Access Compliance Report

Public Rights-of-Way

(Curb Ramps)

Intersection ID: 27411	Main Street: BALLANTYNE_COMMONS_PY	Cross Street: BALLANTYNE_CORPORATE_PL	Location: NW
ADA ID: 501989972FEC	Ramp Type: Perp	Initial Pass/Fail: Fail	Overall Compliance: No
Severity Score: 12.5			
Codes/Mitigation Info/Possible Solution		Field Measurements/Component Compliance

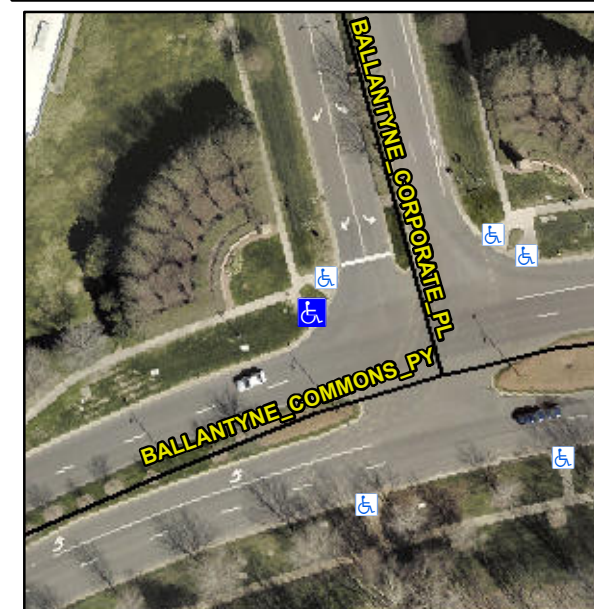
Not Found, R304.5.3

Compliance	Description	Data	Compliance	Description	Data
N/A	Ramp Length (in)	163.0	Yes	Ramp Slope (%)	7.8
Yes	Ramp Width (in)	48.0	No	Ramp XSlope (%)	6.7
N/A	Flare Type LT	N/A	N/A	Flare Type RT	N/A
N/A	Flare Slope LT (%)	N/A	N/A	Flare Slope RT (%)	N/A
N/A	Flare Traversable LT?	N/A	N/A	Flare Traversable RT?	N/A
N/A	Landing Length (in)	N/A	N/A	DWS Provided?	N/A
N/A	Landing Width (in)	N/A	N/A	DWS Contrast?	N/A
N/A	Landing Slope (%)	N/A	N/A	DWS Length (in)	N/A
N/A	Landing X Slope (%)	N/A	N/A	DWS Full Width?	N/A
N/A	Landing Curb? (Y/N)	N/A	N/A	DWS Offset (in)	N/A
N/A	Shared Landing?	N/A			
N/A	Gutter Ponding?	N/A	N/A	Gutter Slope (%)	N/A
N/A	Gutter Lip Ht (in)	N/A	N/A	Gutter X Slope (%)	N/A
N/A	Painted X Walk1?	No	N/A	Painted X Walk2?	N/A
	X Walk 1 Direction	To S		X Walk 2 Direction	N/A
N/A	X Walk 1 Width (in)	N/A	N/A	X Walk 2 Width (in)	N/A
	X Walk 1 Slope (%)	4.0		X Walk 2 Slope (%)	N/A
	X Walk 1 X Slope (%)	2.3		X Walk 2 X Slope (%)	N/A

Remove & Replace Entire Ramp.
